IMPORTANT SAFETY RECALL NOTICE

Transport Canada Number: **2026-293**

Winnebago Motorhomes has decided that certain 2026 – 2027 Winnebago Revel and Revel Sport fail to conform to Federal Motor Vehicle Safety Standard No. 110. "Tire Selection and Rims". These vehicles were manufactured February 19, 2025, through May 23, 2026. These dates are a broad overview and non-sequential.

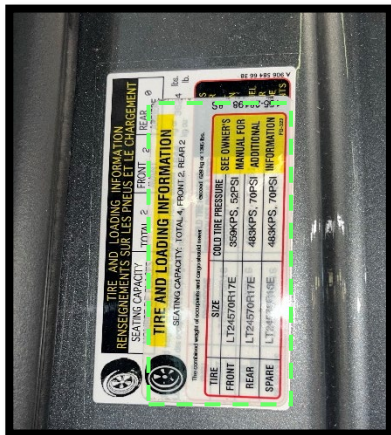
Defect: Certain Winnebago vehicles fail to comply with FMVSS 110 due to an incorrect tire size listed. The tire is listed as R16 when actual tire size is R17.

2. Remove and discard existing Tire and Loading Information Label, this will reveal the OEM chassis manufacturer's Tire Inflation Pressure Label.

KEEP OEM Chassis Manufacturer's Tire Inflation Pressure Label .

REMOVE and discard existing Tire and Loading Information Label

3. Clean the face of the OEM Label with Isopropyl alcohol and ensure it is dry. Then cover the OEM Tire Inflation Pressure Label with the new Tire and Loading Information Label provided in this letter.
